Outstanding Items Report – 11/04/2020

Project: Niles Barnard Renovation Project
Project No: 0128-18-0020
Date: November 4, 2020

Owner: City of Troy

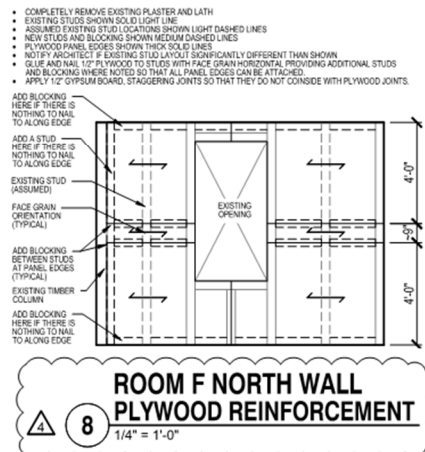
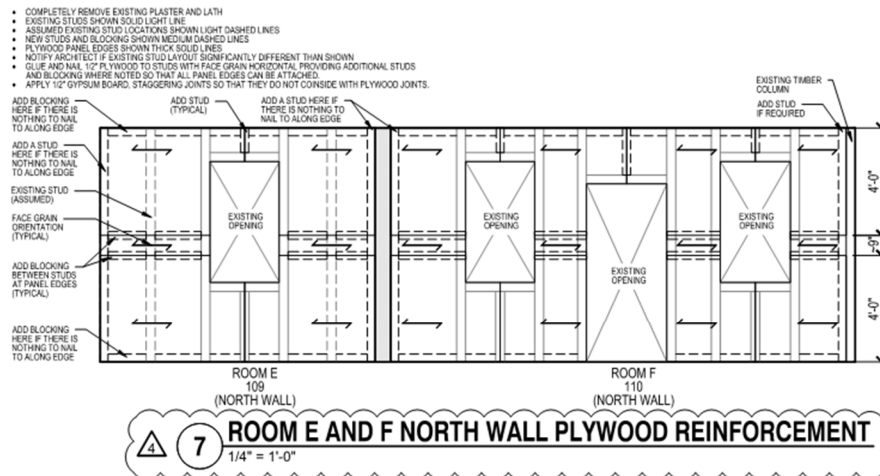
1. Items from 2020-03-18 Site Observation Report: Verification Photo:
 - a. Existing beam left unsupported at end. Provide beam hanger by Simpson Strong-Tie or KantSag to attach existing timber beam to new double LVL beam w/ beam hanger. (Labeled as "D" in photo below)
- Completed date: 2020 - - Verified by:

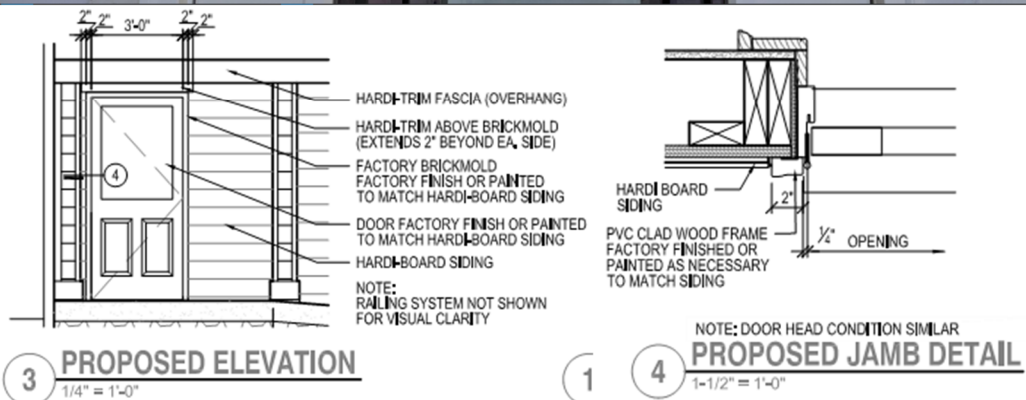
- a. Nail removal and painting needed at building and columns where existing railing removed from porch at door 101A**

8 ACCESS HATCH DETAIL

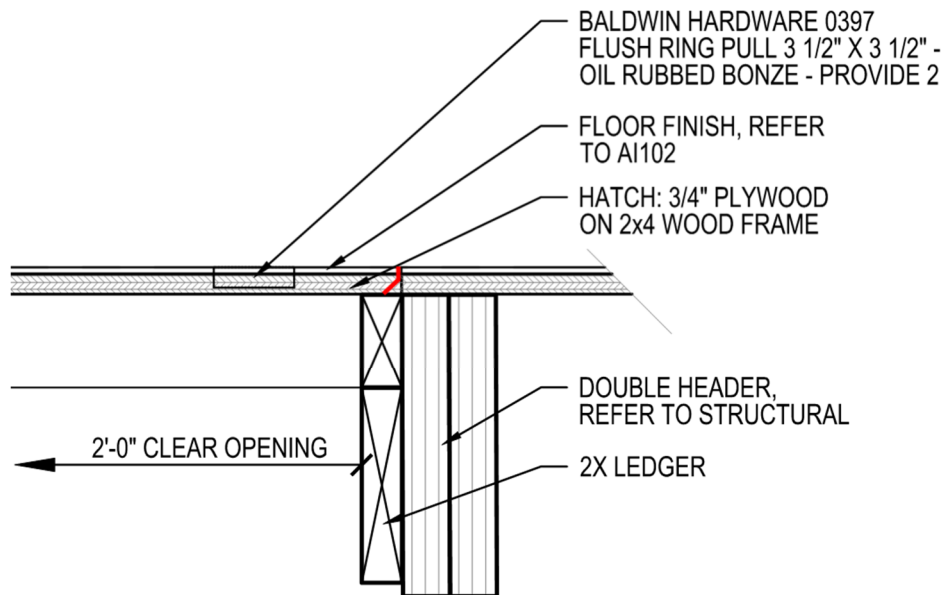
- c. **Crawlspace hatch difficult to install, linoleum overhangs hatch panel and is peeling from surface of panel. Chamfer edge of hatch panel as sketched below, trim linoleum flooring to extents of panel, install specified opening hardware.**
